Subject: **Palo Verde Nuclear Generating Station (PVNGS)  
Units 1, 2, and 3  
Docket Nos. STN 50-528, 50-529, and 50-530  
Renewed Operating License Nos. NPF-41, NPF-51, NPF-74  
Response to NRC Electrical Engineering Branch Staff Request for  
Additional Information Regarding License Amendment Request to  
Revise Technical Specifications Related to Degraded and Loss of  
Voltage Relay Modifications**

**Response to NRC Electrical Engineering Branch (EEEB)  
Requests for Additional Information (RAIs) Regarding  
License Amendment Request (LAR) to Revise Technical  
Specifications Related to Degraded and Loss of Voltage  
Relay Modifications**

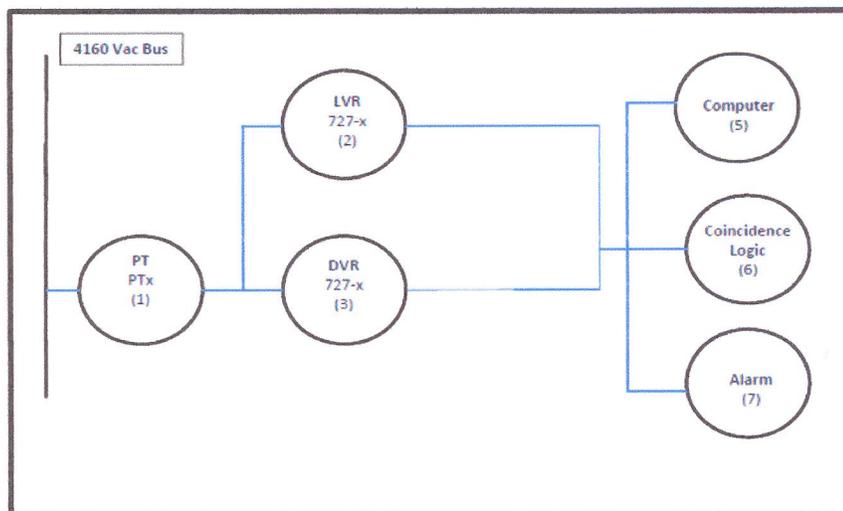
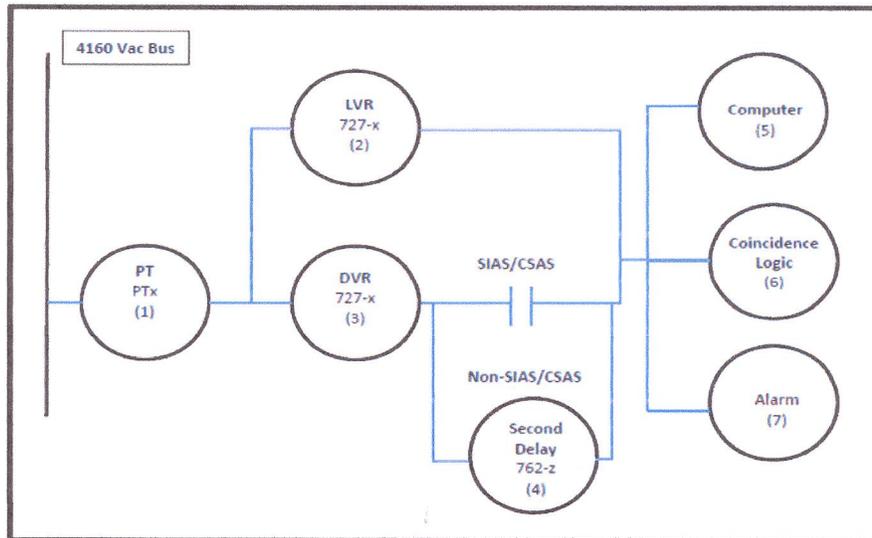
- a. A tabulated summary of the DVR setpoints (single stage and two stage) and the protective function performed by each relay for the postulated degraded conditions.
- b. A tabulated summary of the LVR setpoints and the protective function performed by each relay for the postulated degraded conditions.
- c. A diagram depicting the transitional, "in-progress," and final configuration of the safety-related buses in light of the DVR modifications discussed in this LAR.

**APS Response RAI-1, Subpart c:**

The modification will be implemented on one Class 1E bus (train) in each refueling outage. Each PVNGS Unit will, therefore, operate one full fuel cycle with one modified Class 1E train and one Class 1E train with the existing configuration as an interim configuration. The interim configuration will exist until the modification is completed on both Class 1E busses (trains) on that PVNGS Unit.

The following simplified diagram (one of 4 channels) depicts the configuration for a single Class 1E bus before the modification is installed:

Both LVR and DVR have voltage sensing and timer elements. The DVR is an ABB Type 27N relay. When voltage drops to the dropout (setpoint) the timer starts. If voltage rises above the pickup (reset) the timer stops. If voltage does not rise above the pickup (reset) before

the predetermined timer setpoint then the DVR trips and sends the signal onward, as shown. The LVR is a GE inverse time delay relay, in that the lower the voltage, the shorter the time before the LVR trips and sends the signal onward.

The following simplified diagram (one of 4 channels) depicts the configuration for a single Class 1E bus after the modification is installed:

Both LVR and DVR have voltage sensing and timer elements. The modified DVR is a slightly different model than before the modification. Before the modification, the DVR was ABB Type 27N, model 411T7375-HF-L-DP. After the modification, the DVR is ABB Type 27N, model 411T4375-HF-L-DP. The only difference is the "4" after the "T" in the model number, which indicates that the timer range is 1-10 seconds instead of the existing 10-100 seconds. The signal from each PT (device 1) is sent to both the LVR (device 2) and DVR (device 3). The output from a given pair of both DVR and the LVR (devices 3 and 2) go to a single computer point (device 5) and to a single alarm point (device 7). Either DVR or LVR, or both of the pair can send the trip signal related to a given PT to the coincidence logic (device 6). For a given train, if two of the four inputs to the coincidence logic are tripped a loss of power signal is sent.

The LVR senses voltage and when it drops below the setpoint it starts the timer. After the modification, the LVR model number will be ABB Type 27N model 411T4375-HF-L-DP, the same as the DVR. If it times out before being reset by voltage rising above the reset value, the signal is sent onward.

The DVR also senses voltage in the same manner as the LVR but with different voltage and timer setpoints. When the DVR trips, a signal is sent to both the relay labeled as SIAS/CSAS (Containment Spray Actuation Signal) and to the second delay timer. If a SIAS/CSAS is present, the relay is closed and the signal passes directly on to the coincidence logic, etc. The time delay is the timer part of the DVR. If a SIAS/CSAS is not present, the signal is controlled by the second delay timer (device 4). It is a simple timer (no voltage sensing) that starts timing when it receives the signal from the DVR and trips when it times out. The total time delay for the non-SIAS/CSAS condition is the sum of the DVR timer and the second delay timer.
